THE VILLAGE

PRELIMINARY PH. 1-3 & CONDITIONAL USE PERMIT

Subject: The Village Development – Preliminary Review

LUSTER
THE VILLAGE
PHASING PLAN

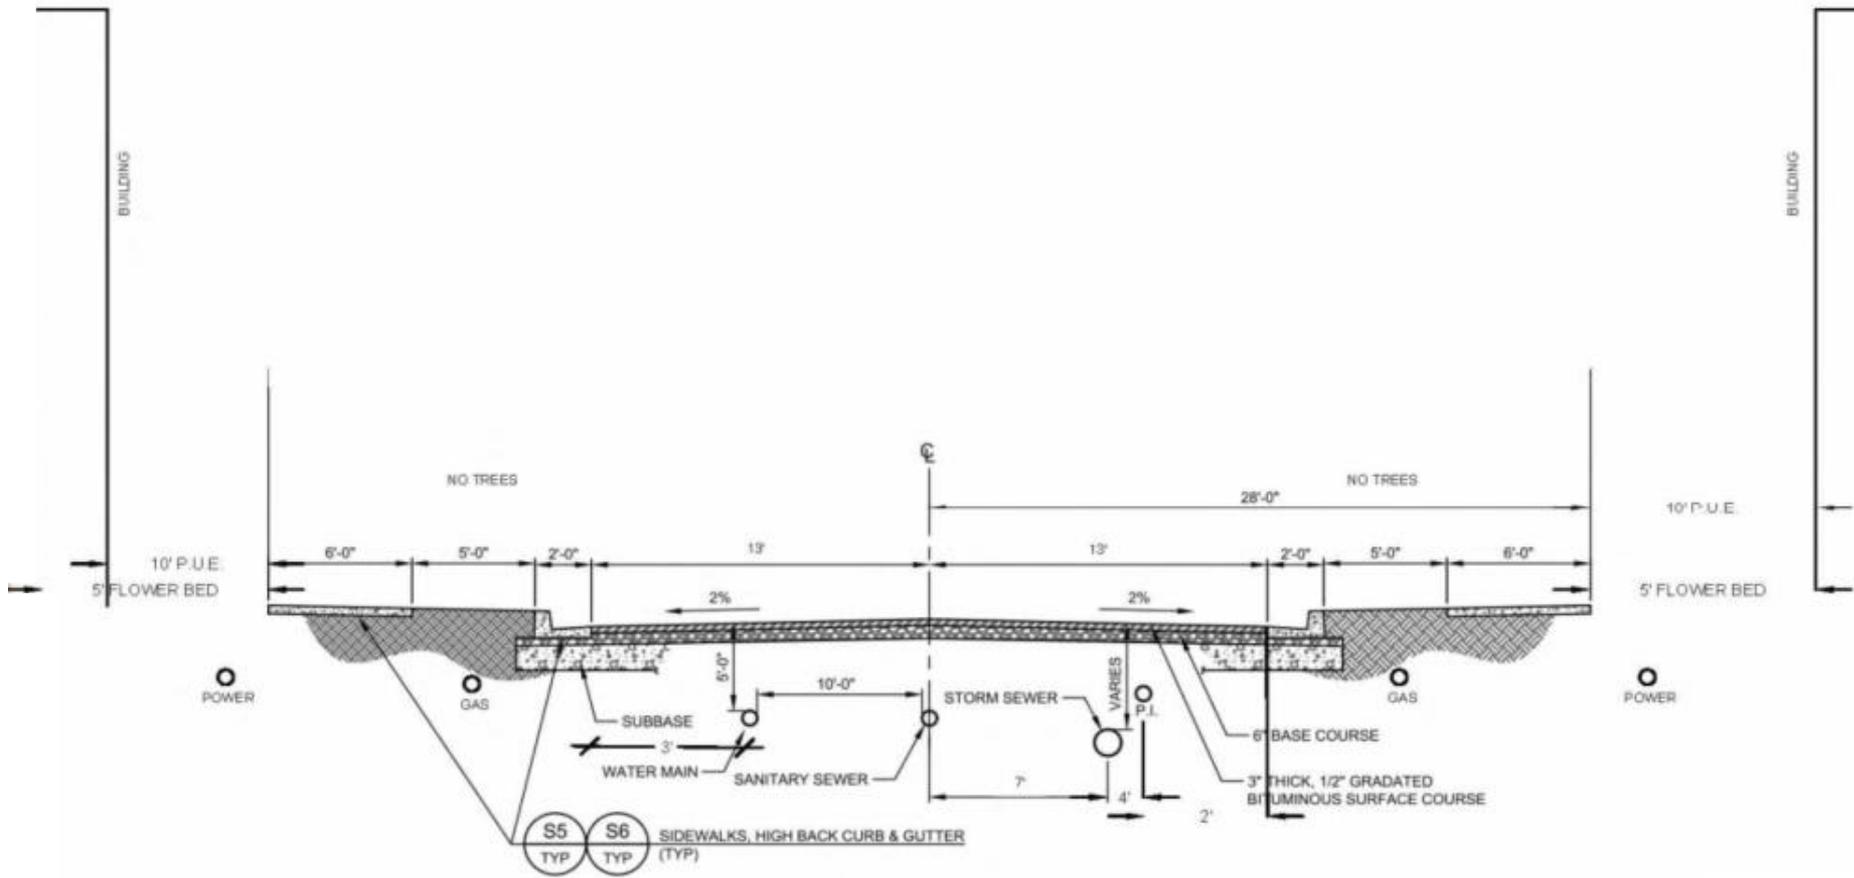
- Water rights
 - Phase 1: 32.44 acre-feet
 - Phase 2: 38.57 acre-feet
 - Phase 3: 41.18 acre-feet
 - Phase 4: 37.37 acre-feet
 - Phase 5: 17.04 acre-feet
 - Total: 166.6 acre-feet
 - Water rights per commercial buildings will be noted on the plat. Commercial uses may require more water rights than what will be dedicated. If more water is required, the applicant must supply the required water before the use is approved.
- Traffic study
- Roads & traffic circulation
 - Temporary connector access

- NOTES**
1. TEMPORARY CUL-DE-SAC TO BE INSTALLED WITH PHASE 1, AS SHOWN.
 2. RIVER ROAD CONNECTION TO BE COMPLETED WITH PHASE 3.
 3. TRAFFIC LIGHT AT RIVER ROAD AND MAIN MUST BE INSTALLED PRIOR TO PHASE 3. SEE THE MASTER PLAN AGREEMENT FOR ADDITIONAL DETAILS.

Exhibit D
Transient Overlay Zone
(Residential Units in Transient Overlay Zone)

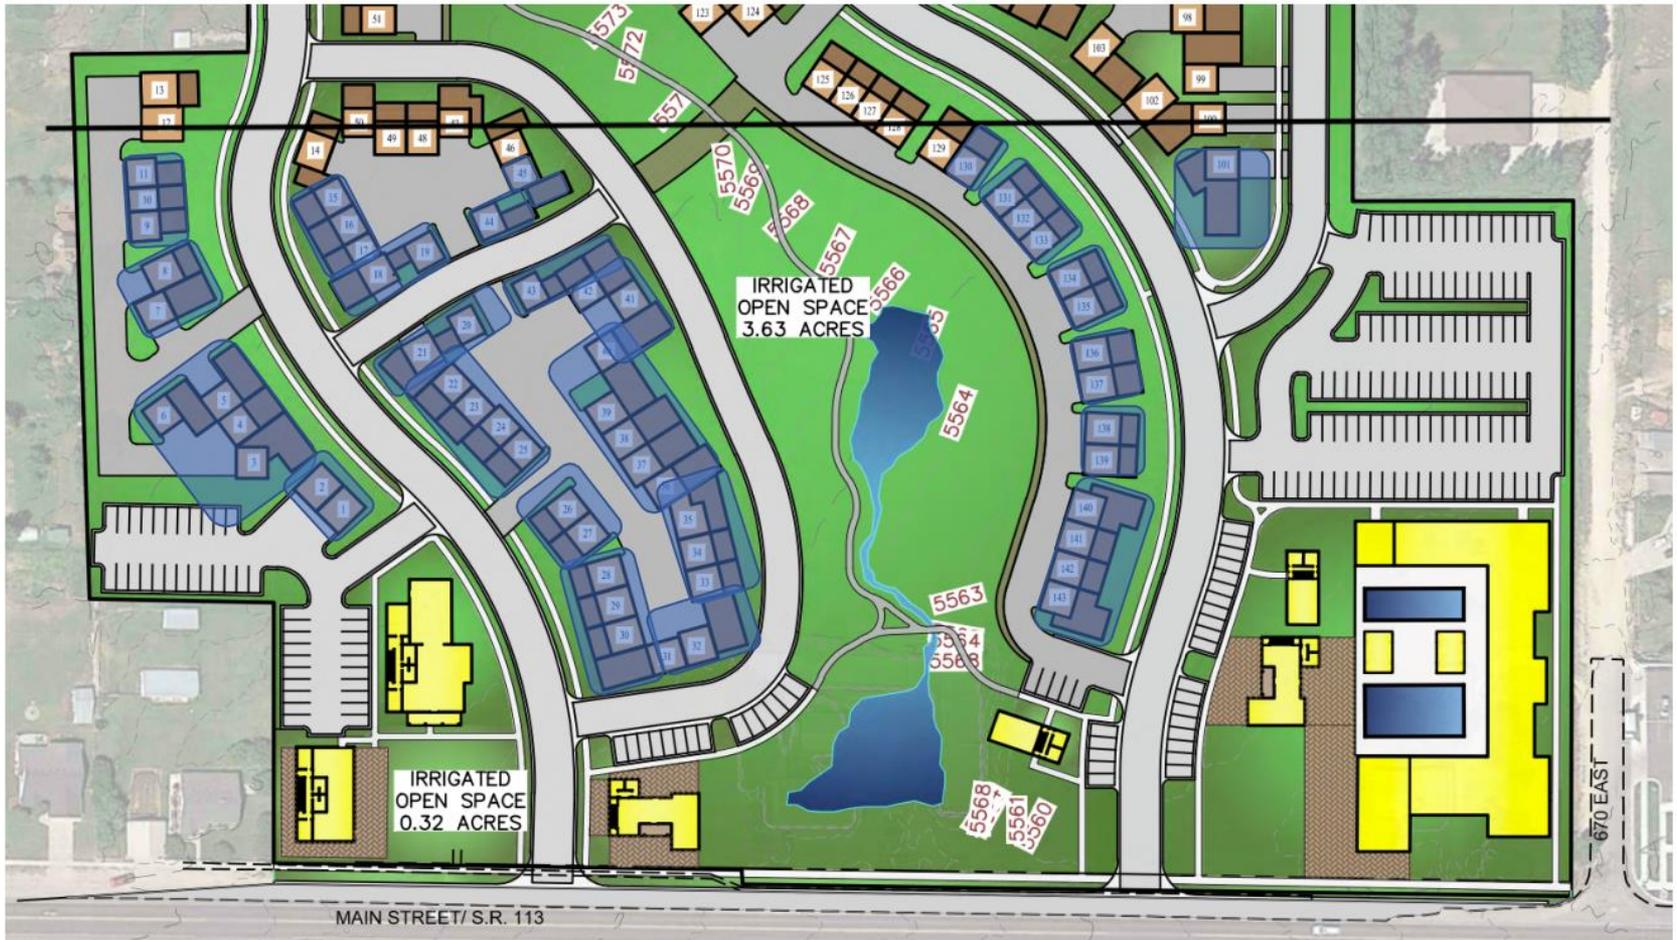
- Property owners' association
 - All five phases of, including both residential and commercial, will be under one POA
- Geotechnical reports
- Mailbox locations
- Transient Rental Overlay District

LUSTER THE VILLAGE
 PRELIMINARY TYPICAL BUILDING LANDSCAPE PLAN

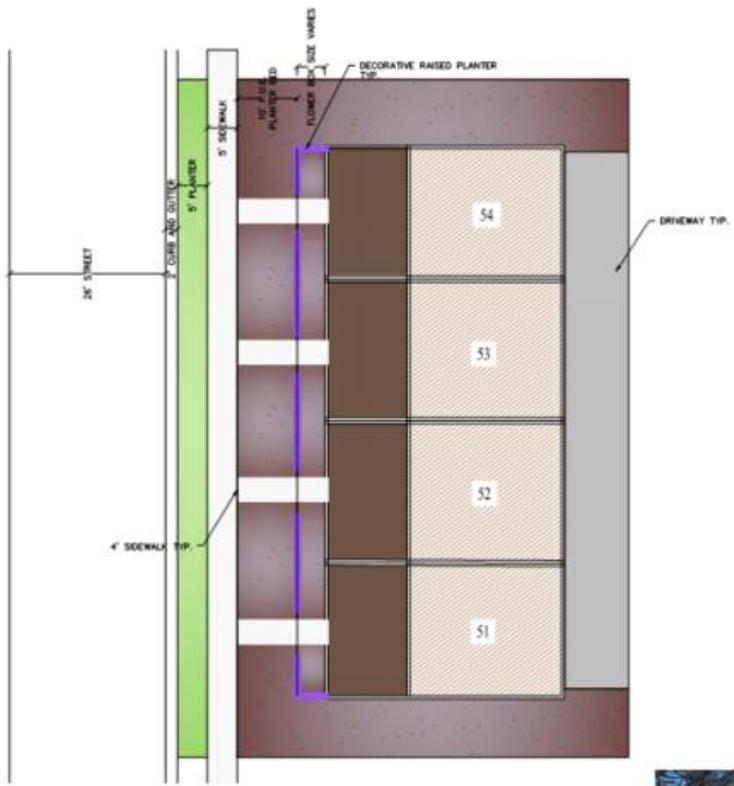
- Commercial area landscaping
 - More detailed landscaping plan required for final approval
 - Bond will include all landscaping shown on the plans
 - Commercial building sites must be either kept in agricultural production until constructed or, once those areas are developed, the commercial pads and surrounding area, are landscaped until the structures are built
- Residential area landscaping
 - More detailed landscaping plan required for final approval
 - Bond will include all landscaping shown on the plans
